Follow-up to COM Commit Request Number 4p8_5

COM Commit Request Number 4p9_1

**Hossein Shakiba
Huawei Technologies Canada
June 17 2025**

Slide 8 of "[shakiba_3dj_COM_03_2505.pdf](#)"

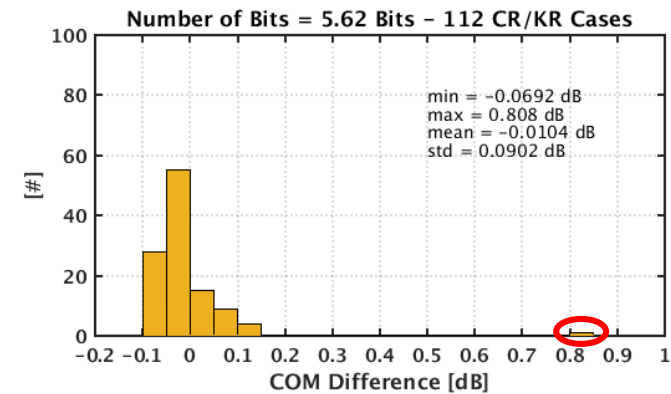
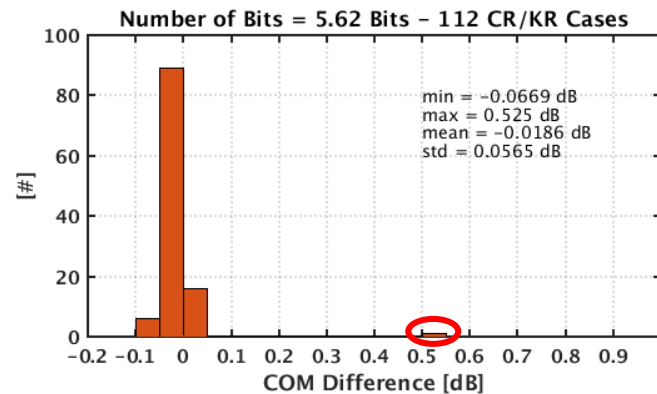
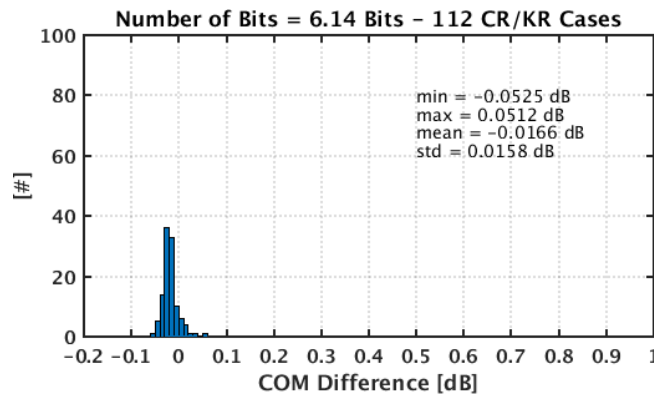
- Options to consider for commit request 4p8_5:
 - 1) Fix the issue and fully implement change #4 of commit request 4p7_4 and accept 2x increase in the run time
 - 2) Revert the change (although not implemented properly) and reduce the run time overhead from 106% to only 3%
 - No change to COM results relative to version 480
 - A very small penalty to COM results if the change were implemented properly (see next slide)
 - 3) Have both options (already implemented in the code) and a switch to select the method
 - 4) Defer the decision and continue to investigate the impact on COM for more cases
- Open to discussions and decision on options

Test Results and Final Suggestion

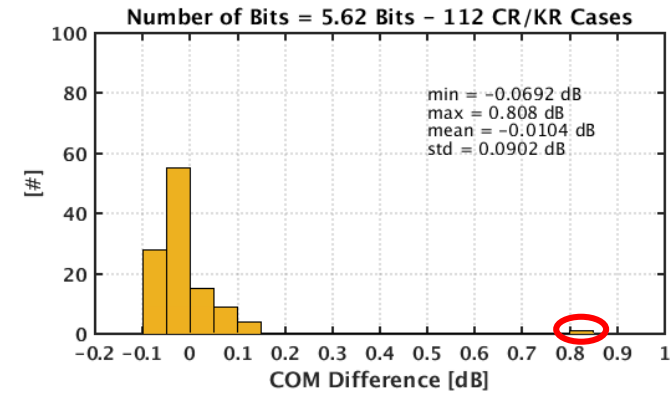
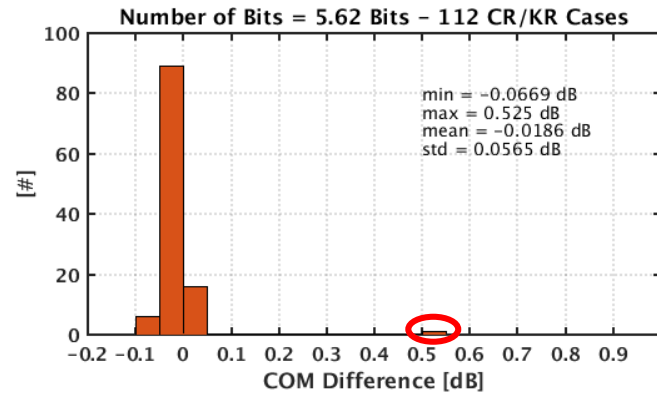
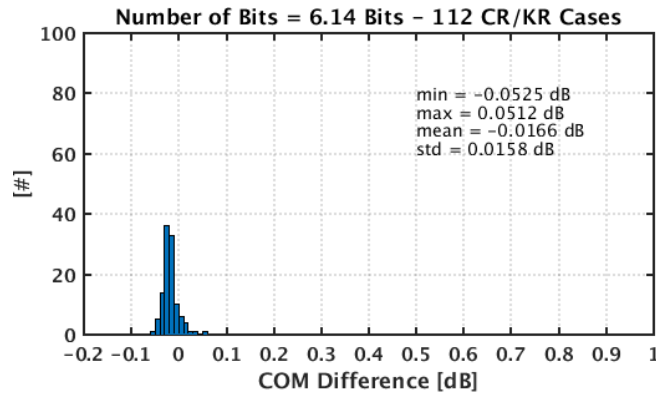
- After adding the switch, the same 3x112 test cases were run again and exact same COM difference between two methods was confirmed

- Runtime overheads with two “Fast” and “Slow” methods relative to when quantization noise is disabled demonstrated an almost 2x slower runtime for the “Slow method”
- “Fast” method overhead reduced from 3% to 1% due to additional saving explained in slide 4

Average Runtime Overhead “Fast” Method	Average Runtime Overhead “Slow” Method
1% Overhead	99% Overhead

- It is suggested to proceed with the change and default the “Clip Method” switch to “Fast”
